Flat Type E Planning Outline

Drawing status FOR COMMENT

Project Name County Flats, Sandfields
Project Ref OAD_5174
Drawing Ref 1230
Drawing Name Flat Type Boz.2
Drawn By WS
Date 22.04.2021

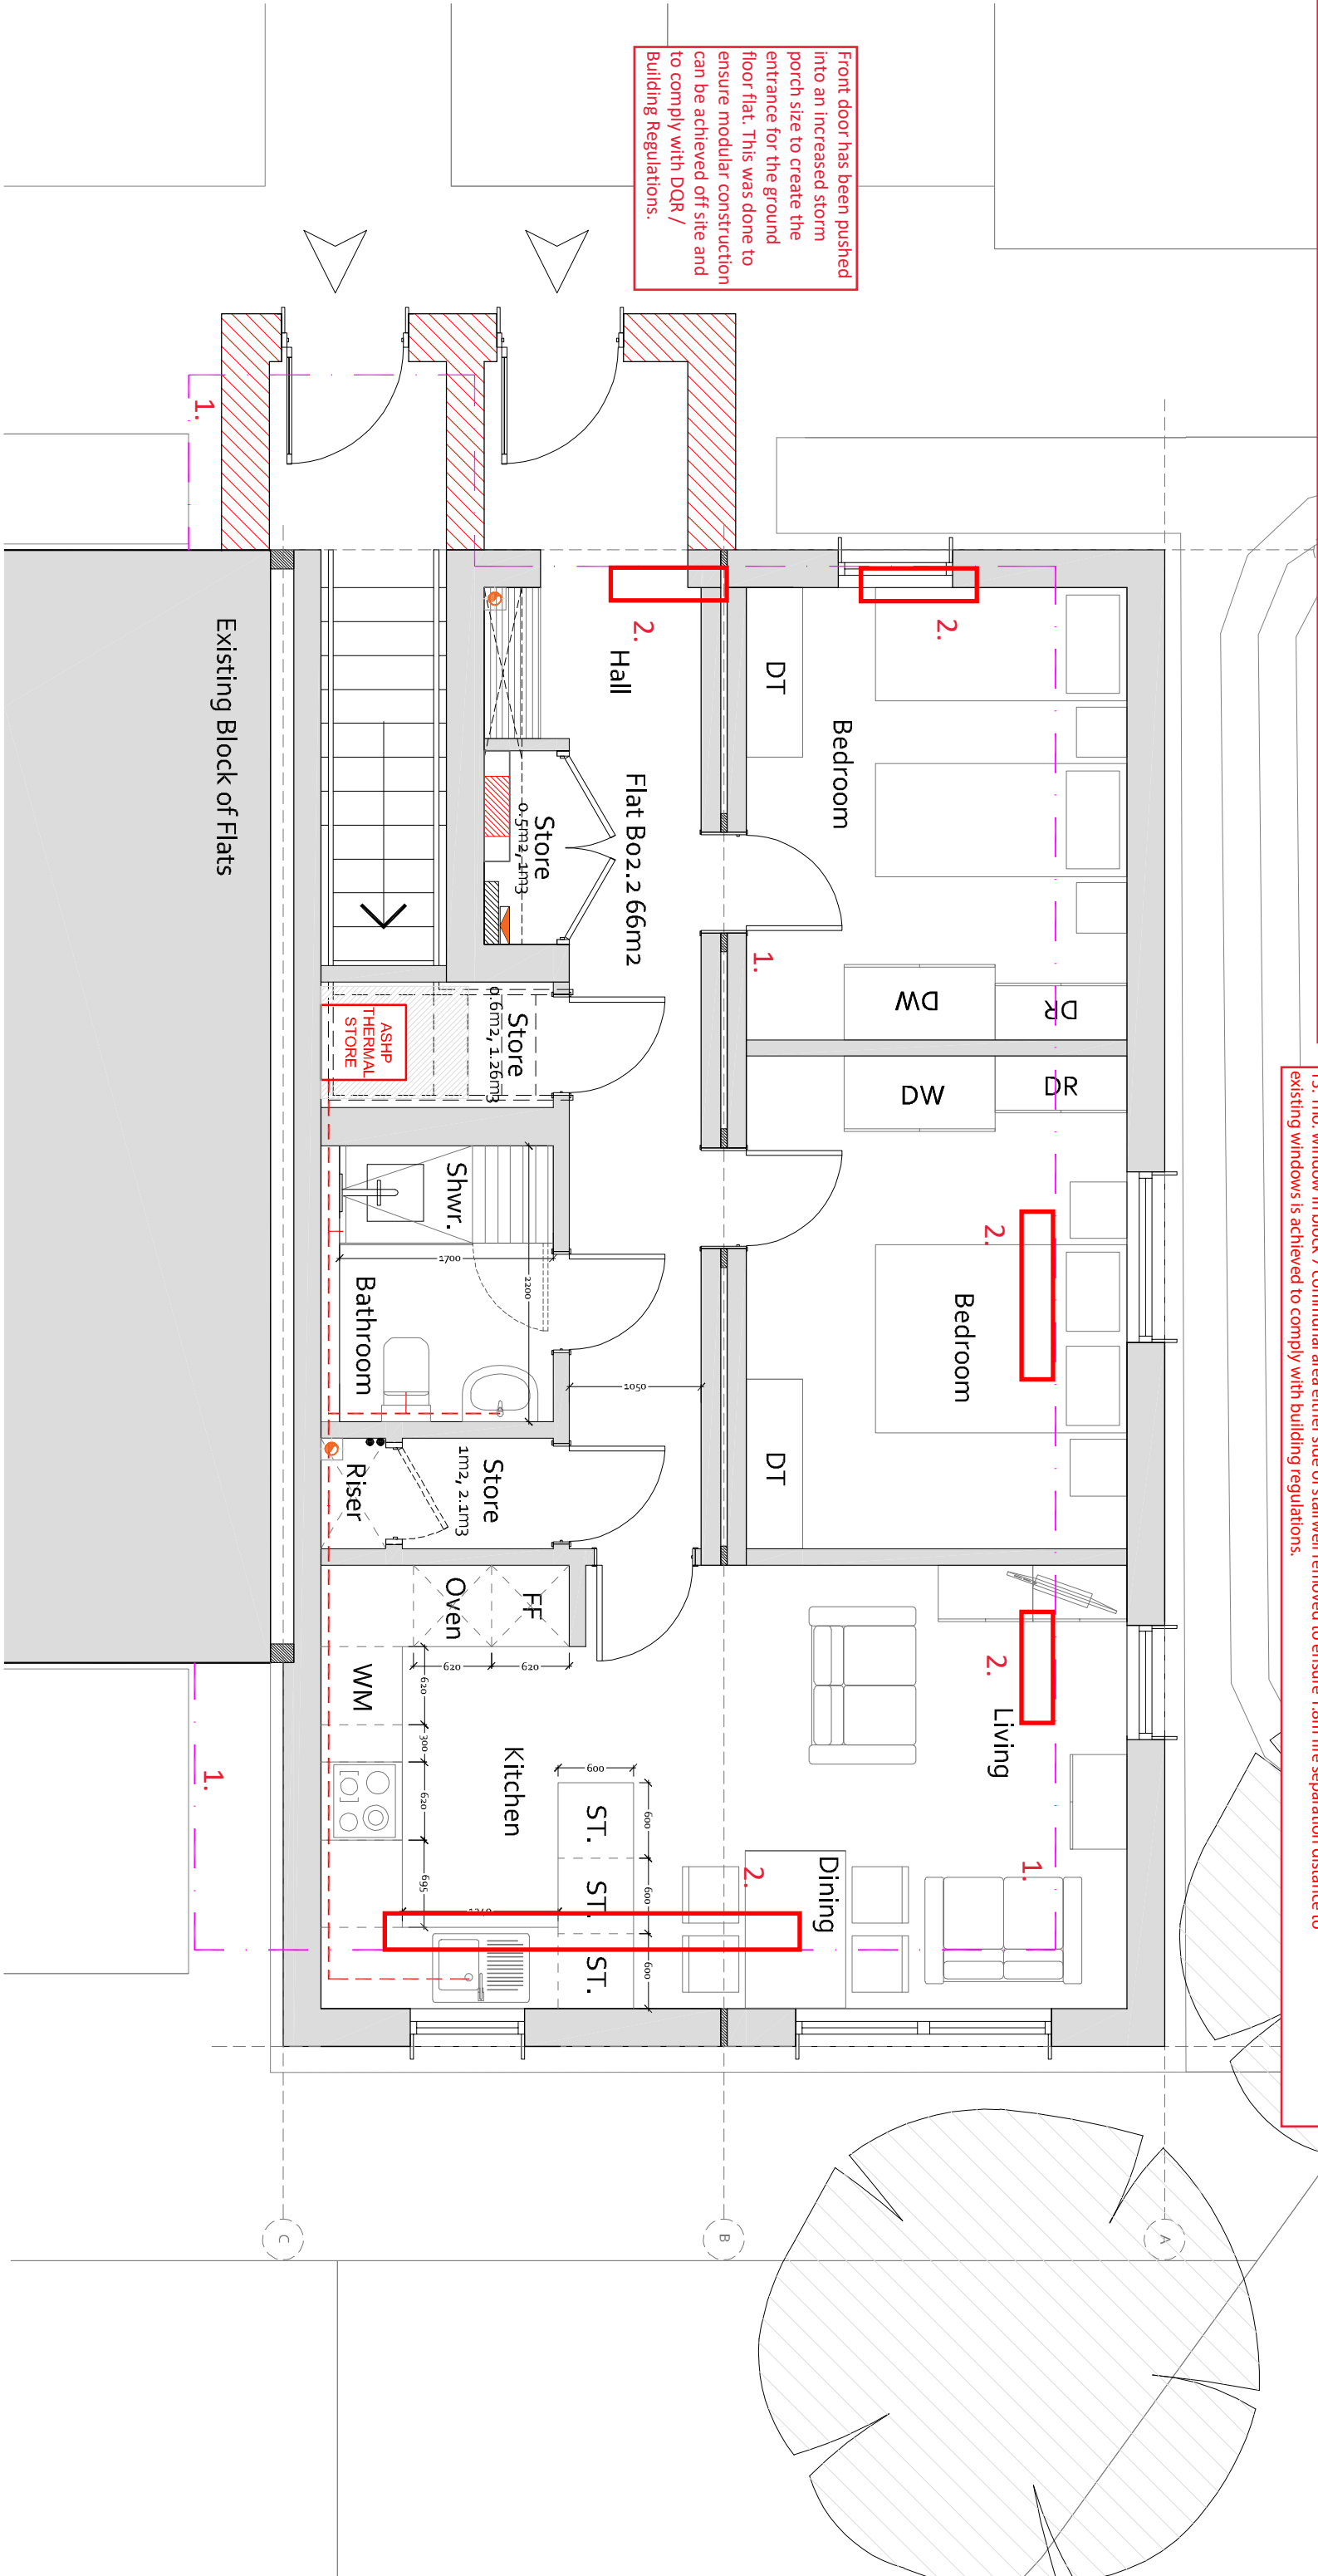
- DESIGN CHANGES
1. Modular end links re-positioned slightly off existing buildings, with the party wall straightened and porch projections aligned with this wall, to ensure modular construction can be achieved off site.

2. Windows have been slightly re-positioned to the new build to suit the structural design of the modular units and the constraints of the timber frame.

3. Parapet to modular end blocks have been lowered by approx 900mm to comply with the structural wind loadings and timber frame design.

4. Corner windows have been removed and replaced with 2no. Windows on either corner, again due to the structural and timber frame design of the blocks.

5. PV panels have been omitted from the end modular units to suit the structural and timber frame design of the blocks.

6. Ground floor Juliet balcony added to existing flats to provide better security whilst ensuring the open areas remain as communal spaces.
7. Air source heat pump external louvre enclosure amended to be single storey over entrance canopy to end link blocks.

8. External air source lowered enclosure handed to provide internal riser/access requirements for maintenance.
9. Buggy/cycle store added to block 6 and 7 parking courtyards.

10. Bin stores slightly re-positioned to suit existing drainage runs, with bin store near block 6 amended in size to suit located of bedroom window.
11. Footpaths amended to be Tarmac.

12. Windows in communal area to the linked blocks made narrower to ensure 1.8m fire separation distance to existing windows is achieved to comply with building regulations.

13. 1no. window in block 7 communal area either side of stairwell removed to ensure 1.8m fire separation distance to existing windows is achieved to comply with building regulations.

Front door has been pushed into an increased storm porch size to create the entrance for the ground floor flat. This was done to ensure modular construction can be achieved off site and to comply with DQR / Building Regulations.
